Access Compliance Report

Public Rights-of-Way

Intersection ID: 17739	Main Street: E_WOODLAWN_RD	Cross Street: SOUTH_BV	Location: NE
ADA ID: D304D4E51CBD	Ramp Type: Perp	Initial Pass/Fail: Fail	Overall Compliance: No
			Severity Score: 26.25

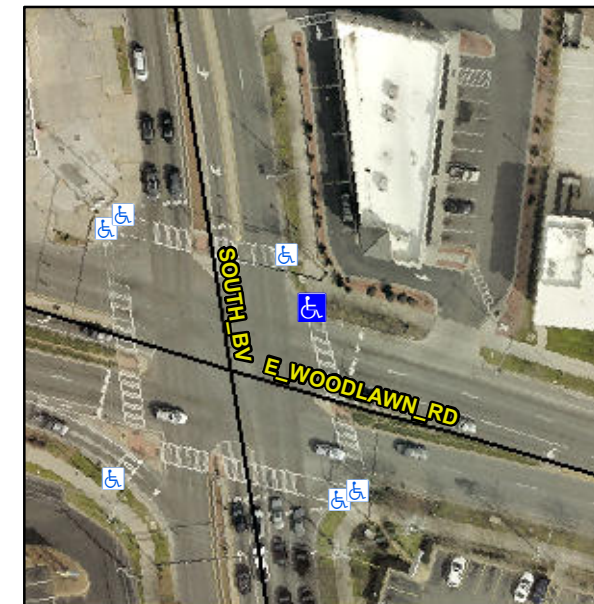
R304.2.2, R304.5.3

Compliance	Description	Data	Compliance	Description	Data
N/A	Ramp Length (in)	80.0	No	Ramp Slope (%)	12.4
Yes	Ramp Width (in)	48.0	No	Ramp XSlope (%)	2.2
N/A	Flare Type LT	N/A	N/A	Flare Type RT	N/A
N/A	Flare Slope LT (%)	N/A	N/A	Flare Slope RT (%)	N/A
N/A	Flare Traversable LT?	N/A	N/A	Flare Traversable RT?	N/A
N/A	Landing Length (in)	N/A	N/A	DWS Provided?	N/A
N/A	Landing Width (in)	N/A	N/A	DWS Contrast?	N/A
N/A	Landing Slope (%)	N/A	N/A	DWS Length (in)	N/A
N/A	Landing X Slope (%)	N/A	N/A	DWS Full Width?	N/A
N/A	Landing Curb? (Y/N)	N/A	N/A	DWS Offset (in)	N/A
N/A	Shared Landing?	N/A			
N/A	Gutter Ponding?	N/A	N/A	Gutter Slope (%)	N/A
N/A	Gutter Lip Ht (in)	N/A	N/A	Gutter X Slope (%)	N/A
N/A	Painted X Walk1?	Yes	N/A	Painted X Walk2?	N/A
	X Walk 1 Direction	To S		X Walk 2 Direction	N/A
N/A	X Walk 1 Width (in)	92.0	N/A	X Walk 2 Width (in)	N/A
	X Walk 1 Slope (%)	3.6		X Walk 2 Slope (%)	N/A
	X Walk 1 X Slope (%)	0.7		X Walk 2 X Slope (%)	N/A

Remove & Replace Entire Ramp.
